**SUBJECT:** Savannah River Site's Responses to the Regulatory Comments on the 2023 Annual Comprehensive TNX Area Groundwater Monitoring and Remedial Action Effectiveness Interim Report (U) (SRNS-RP-2024-00682, Revision 0, June 2024) SEMS Numbers: 21, 29

**SRS Responses to SCDES Comments on the 2023 Annual Comprehensive TNX Area  
Groundwater Monitoring and Remedial Action Effectiveness Interim Report (U), SEMS  
Numbers: 21, 29, SRNS-RP-2024-00682, Revision 0, June 2024  
Savannah River Site, Aiken, South Carolina**

SRS Responses to USEPA Comments on the 2023 Annual Comprehensive TNX Area  
Groundwater Monitoring and Remedial Action Effectiveness Interim Report (U), SEMS  
Numbers: 21, 29, SRNS-RP-2024-00682, Revision 0, June 2024  
Savannah River Site, Aiken, South Carolina

Figure CR-1. Revised Figure A-10 Showing SVE Well Locations and Connections to MicroBlowers™

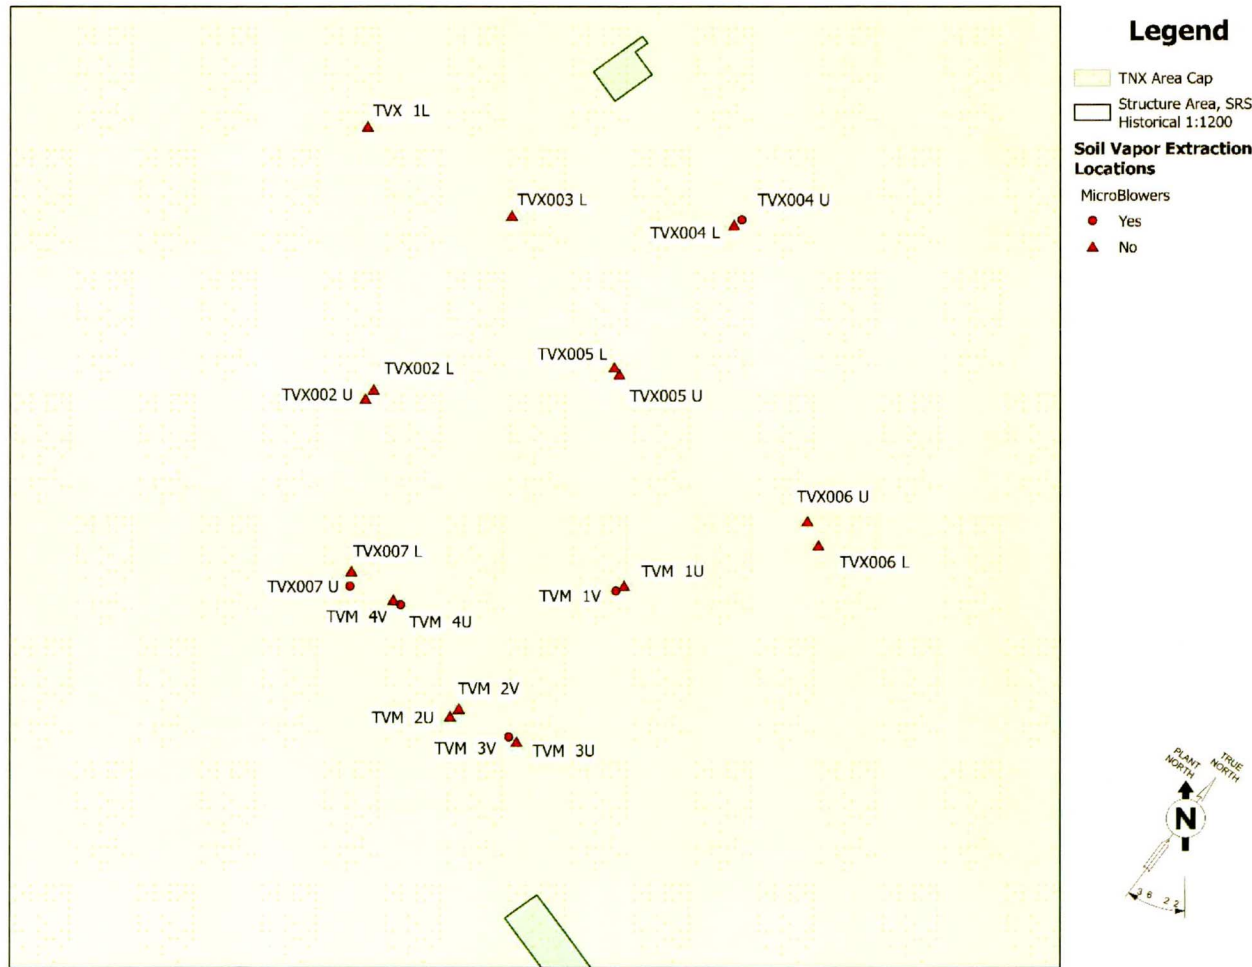
4. The current locations of the five MicroBlowers™ connected to TVM 1V, TVM 3V, TVM 4V, TVX004U, and TVX007U are not specifically identified on Figure A-10, Location of TNX Area SVE [Soil Vapor Extraction] Monitoring Well System. Although the wells are shown on the figure, the figure legend identifies these five MicroBlowers™ wells as soil vapor extraction (SVE) wells. *Please revise the Annual Report to identify the five current locations of the MicroBlowers™ on Figure A-10.*

1. **Section 2.4.2 Soil Vapor Extraction, Page 9 of 62:** The “U” and “L” horizon identifiers are defined in this section; however, the “V” identifier is not defined. In addition, the wells on Figure A-10 (Location of TNX Area SVE Monitoring Well System) have “V”, “U” and “L” in the identifications, but the definition of those identifiers are not provided in the figure. *Please revise the text to define all the screen horizons identifiers used in the SVE wells nomenclature as well as update Figure A-10 to define the identifiers in the legend.*

MicroBlowers™ are connected to soil vapor extraction (SVE) wells at the TNX Area OU and are co-located (TVM 1V, TVM 3V, TVM 4U, TVX004U, and TVX007U). For clarification, a new symbol will be added to Figure A-10 in future annual reports to identify the SVE wells which are connected to MicroBlowers™. An example of the revised map is provided as Figure CR-1.

Text in the third paragraph of Section 2.4.2 will be revised in future TNX Area annual reports to provide this detail with a description of the screen designations. Figure A-10 will include a footnote to reference Section 2.4.2 screen designation descriptions.
